OVERVIEW HILLS

AN ADDITION TO SEDGWICK COUNTY, KANSAS

RE: SUB 2001-51 -- Final Plat of Overview Hills Addition

CASE NUMBER: SUB 2001-51 -- OVERVIEW HILLS ADDITION

OVERVIEW HILLS
AN ADDITION TO SEDGWICK COUNTY, KANSAS

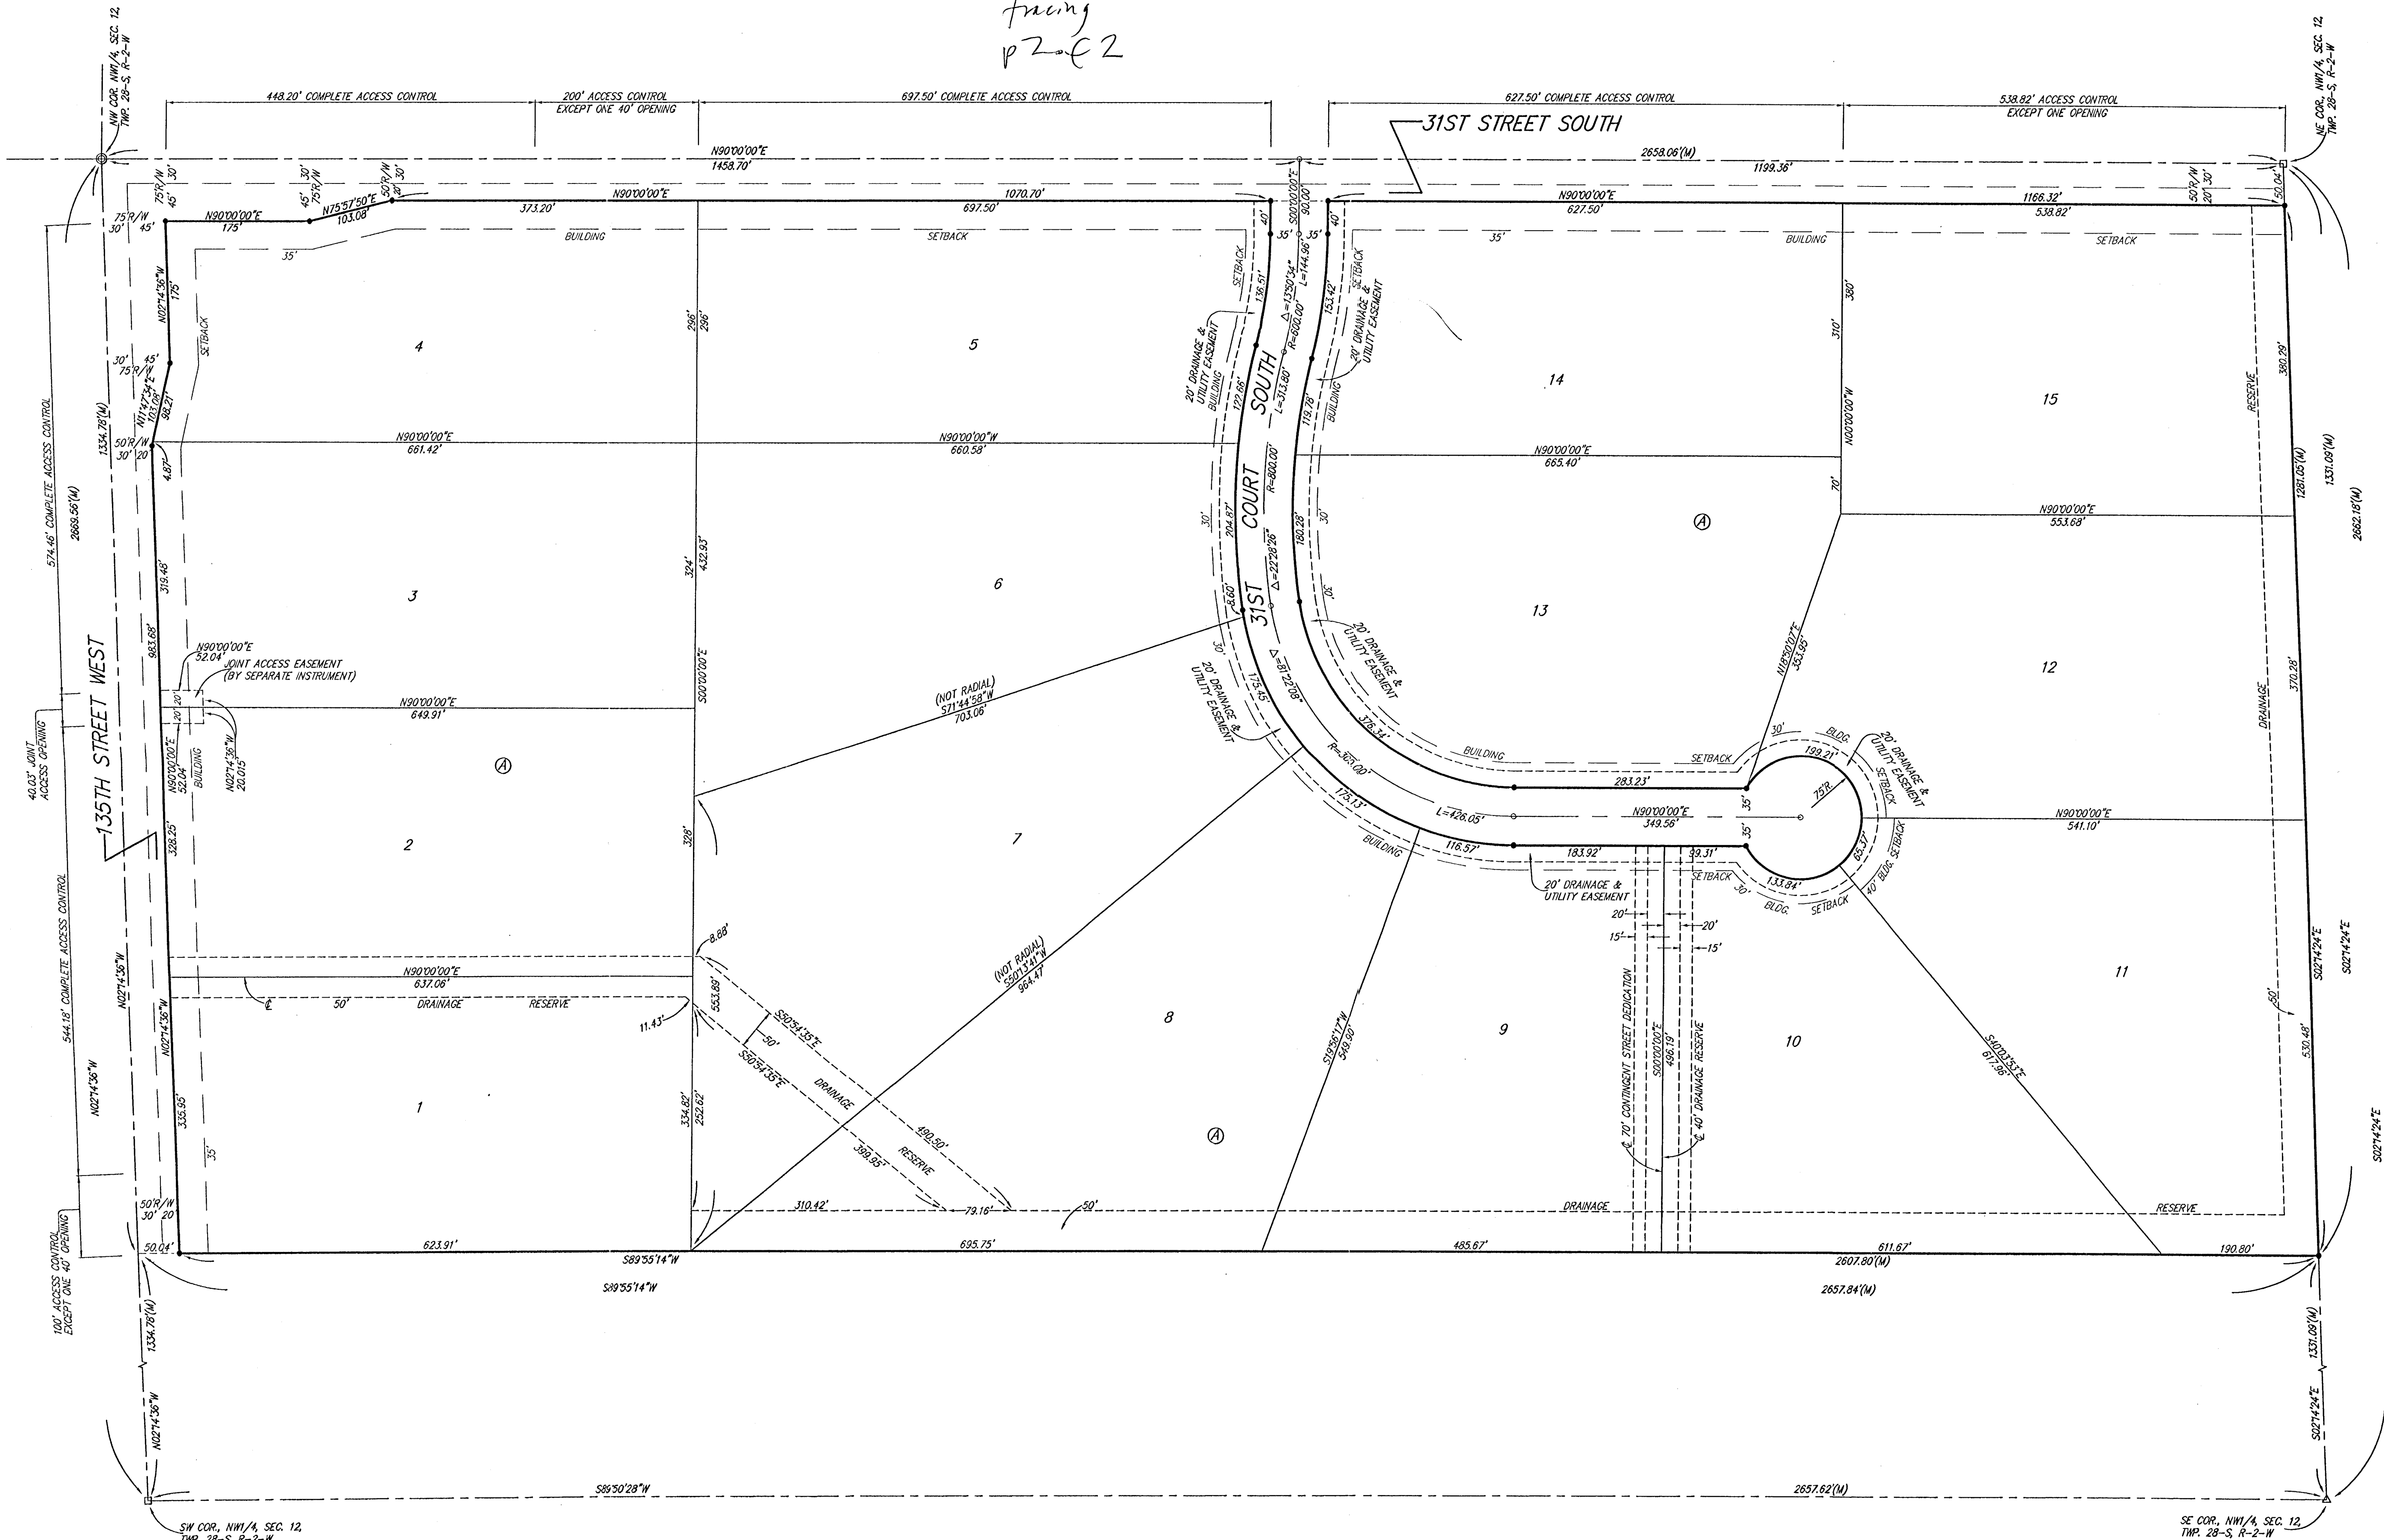
- A. Since sanitary sewer is unavailable to serve this property, the applicant shall contact the Environmental Health Division of the Health Department to find out what tests may be necessary and what standards are to be met for approval of on-site sewerage facilities. A memorandum shall be obtained specifying approval.

- B. The site is currently served by Rural Water District No. 4. The applicant shall contact this water district to determine the ability of this property being platted to connect to their water line and submit a letter to MAPD and Health Department from the water district to that effect.

- E. County Engineering needs to comment on the status of the applicant's drainage plan. *The removal or modification of any terraces or drop structures on the site needs to be coordinated with NRCS. A Master Drainage Plan needs to be submitted.*

- F. County Engineering needs to comment on the access controls. The plat proposes two access openings along 31st St. South, and two openings along 135th St. West, including one joint opening. *The access controls are approved. The 40-ft joint access opening shall be specified.*

- H. The applicant shall guarantee the installation of the proposed streets to the 36-ft rock suburban street standard.
- I. On the final plat tracing, the contingent dedication of street right-of-way needs to be referenced in the plat's text as becoming effective upon the platting of any adjacent subdivision having a street connecting thereto.

- J. Approval of this plat will require a waiver of the lot depth to width ratio of the Subdivision Regulations for Lots 6, 7, 8, and 11. The Subdivision Regulations state that the maximum depth of all residential lots shall not exceed 2.5 times the width. The Subdivision Committee has approved the modification.

- M. Lot 11 may not meet the 100-ft lot width requirement which is measured at the building setback line. This dimension should be denoted on the final plat. An increase in the distance of the building setback from the road would meet the standard. The building setback has been increased to 40 feet.

- N. In the surveyor's certificate and the plat's text, the word "estates" needs to be removed.
- O. The centerline of 31st Street Court needs to be located along 31st St. South.

- P. The location and elevation of permanent on-site Bench Mark needs to be added.
- Q. The plat's text should be corrected to specify "an Addition to ...".

- R. The Planning Commission Certificate needs to have "Kansas" removed from over the word "Sedgwick" and added after the word "Wichita" at the end.
- S. The plat's text shall include language that a drainage plan has been developed for the plat and that all drainage easements, rights-of-way, or reserves shall remain at established grades or as modified with the approval of the applicable City or County Engineer, and unobstructed to allow for the conveyance of stormwater.
